February 1, 1984  
ANPP-28770-EEVB/ACG

Please substitute the attached pages 29 and 30 of Attachment C for the corresponding pages of such attachment enclosed with the advance copy sent to you yesterday of the letter, dated January 31, 1983 (ANPP-28749-EEVB/WEI) from E. E. Van Brunt, Jr., Vice President, Nuclear, Arizona Public Service Company, to the Director, Office of Inspection and Enforcement, U.S. Nuclear Regulatory Commission, which constitutes the Response to Enforcement Letter and Notice of Violations, dated December 12, 1983, File: 84-070-026.

Subject: Response to Enforcement Letter and Notice  
of Violations, dated December 12, 1983  
File: 84-070-026

FIGURE 1 - FRONT LIFTING LUG ASSEMBLY (Two per cabinet)

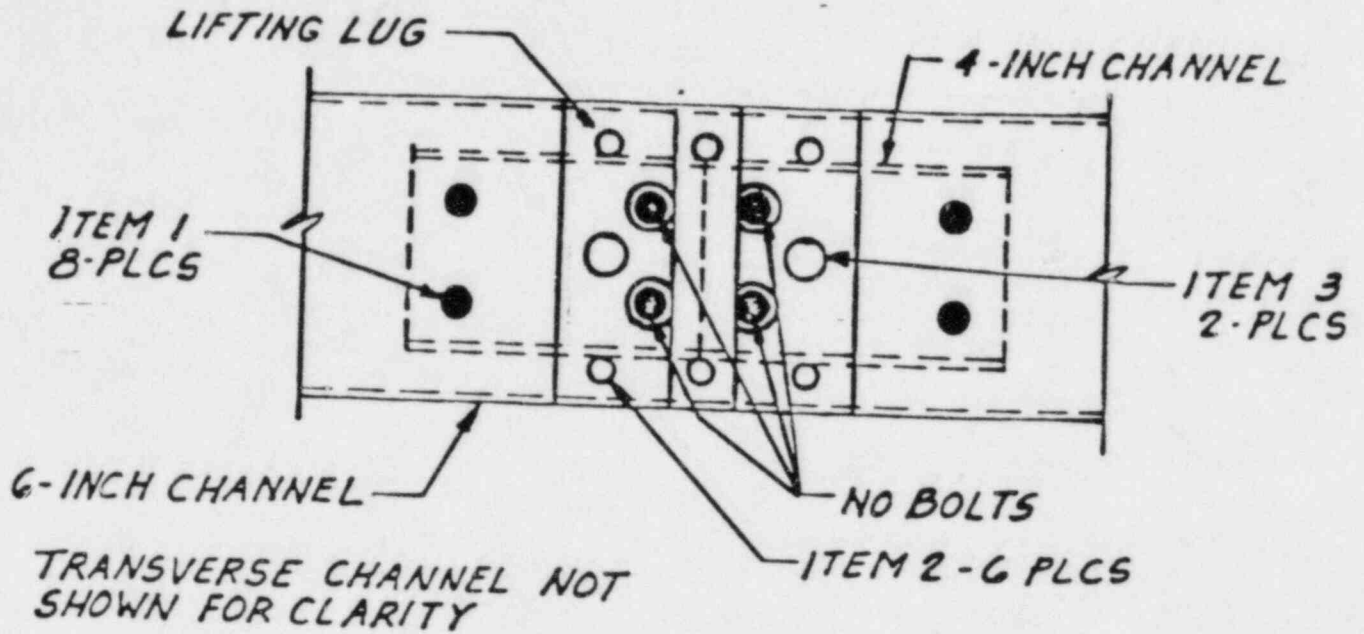
Item 1 - Holes for 3/8 inch diameter mounting bolts which attach the C4 support girt to the C6 base. These bolts are required after lifting lug removal.

Item 2 - Mounting holes for the lifting lugs attachment bolts. No bolts are required after lifting lug removal.

Item 3 - Holes for 5/8-inch diameter bolts used to attach the lifting lug. These bolts are not required after lifting lug removal.

Note A - After lifting lug removal 2-5/8-inch diameter bolts (Item 3) may be installed as a substitute for the 4-3/8-inch diameter bolts (Item 1).

FIGURE 2 - BACK LIFTING LUG LOCATION (Two per cabinet)

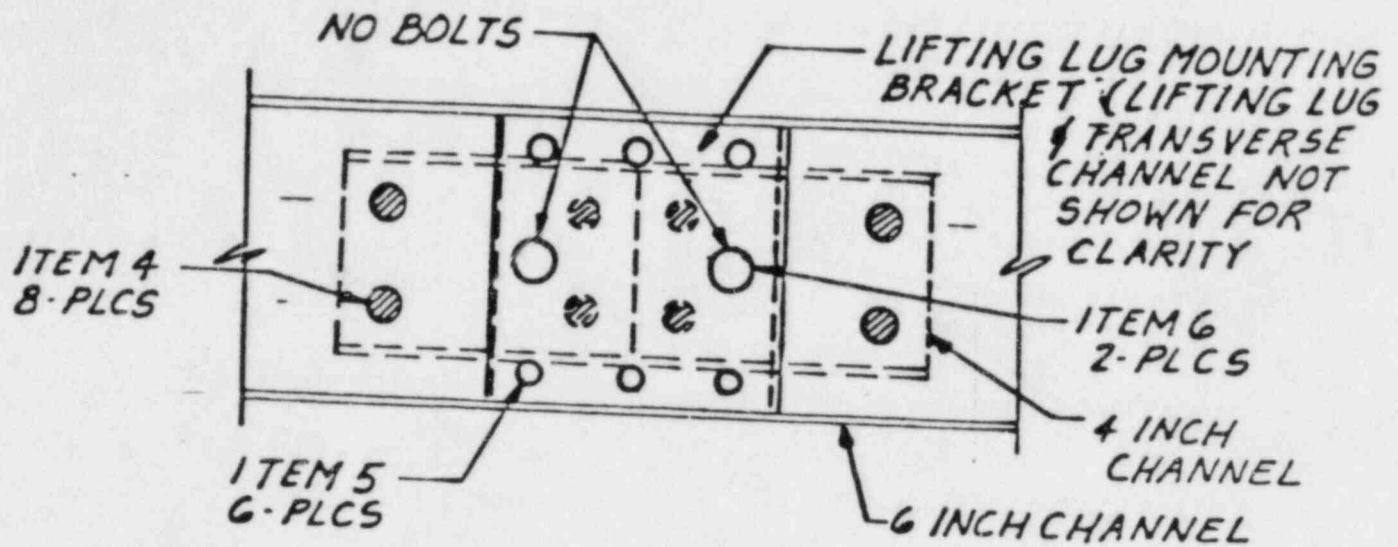
Item 4 - Holes for 3/8-inch diameter mounting bolts which attach the C4 support girt to the C6 base (See Note B).

Item 5 - Mounting holes for the lifting lug attachment bolts. No bolts are required after lifting lug removal.

Item 6 - Holes for 5/8-inch diameter bolts used to attach the lifting lug. These bolts are required to be reinstalled after lifting lug removal.

Note B - The C6 lifting lug mounting bracket, which is welded in place, covers the four middle 3/8-inch diameter bolt locations. This makes installation of the middle 3/8-inch diameter bolts impossible. The two 5/8-inch diameter bolts shall be reinstalled as a substitute after lifting lug removal.

FIGURE 1 - FRONT LIFTING LUG ASSEMBLY (Two per cabinet)

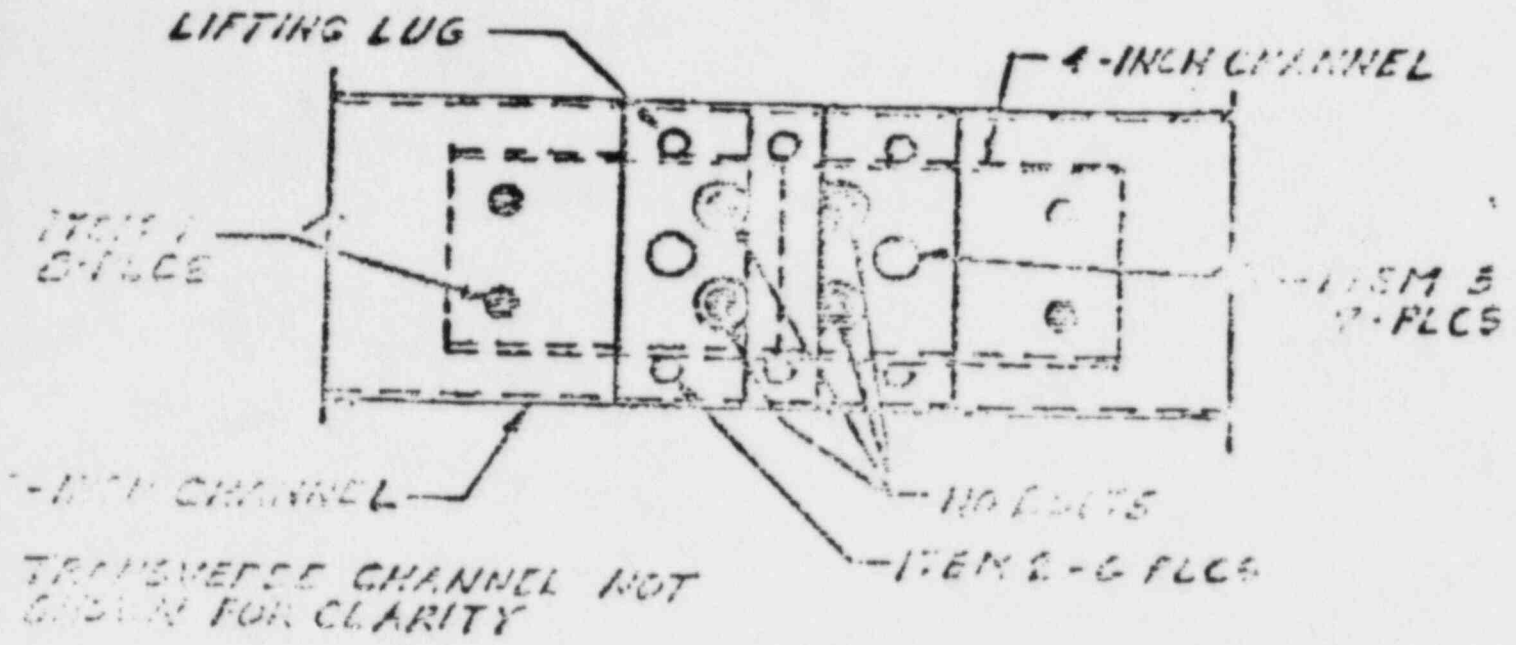
- 2.3 On the front side of the cabinets (See Figure 1), the four 3/8-inch diameter bolts (Item 1) that the lifting lug fits over were either removed when the lifting lugs were removed, or were never installed by General Electric (GE) prior to shipment. For the front side, the 3/8-inch diameter bolts serve as part of the connection between the front base channel (C6, and a parallel channel (C4) which, in turn, is connected to a transverse channel (C4). On the back side of the cabinets (see Figure 2),

Item 1 - Holes for 3/8 inch diameter mounting bolts which attach the lifting lug to the cabinet. These bolts are required after lifting lug removal.

Item 3 - Holes for 5/8-inch diameter bolts used to attach the lifting lug. These bolts are not required after lifting lug removal.

Note: After lifting lug removal 2-1/2 inch diameter bolts (Item 3) can be installed as a substitute for the 4-3/8-inch diameter bolts (Item 1).

FIGURE 1

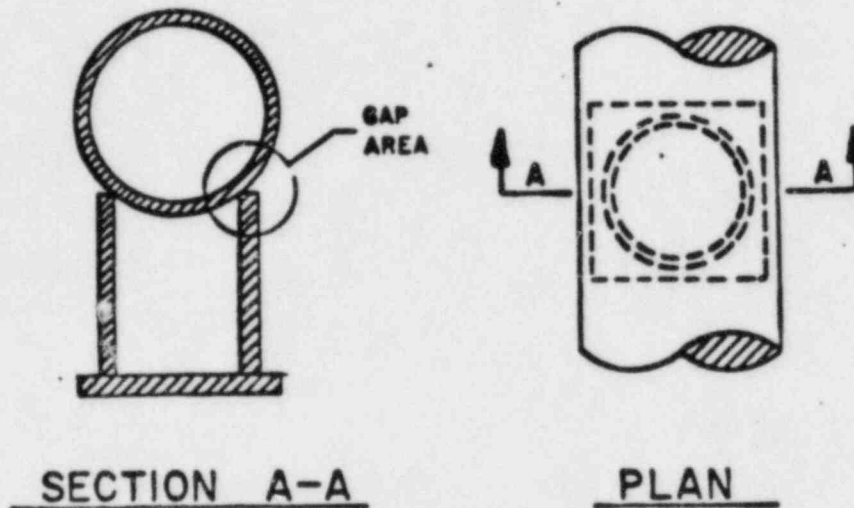
During the NRC inspection of the Safety Injection System, 12 pipe supports were found which did not meet the criteria of the design drawing and applicable tolerances allowed by Procedure WPP/QCI 201.1. The basic concern seems to involve the size and quality of welds which were performed by the craft and accepted by Quality Control. In reviewing the violations, many of the problems are a result of unclear procedures for inspecting welds. Along circumferential areas of piping, problems

arise when a pipe stanchion or a pipe lug is prepared to fit up to a pipe (see Figure 1).

As shown in Section A-A of Figure 1, the normal fit-up of pipe spools and support stanchions leaves a gap between the inside and outside diameters of the stanchions. Although the design drawing specified the pipe spool to support stanchion attachment weld to be an all-around
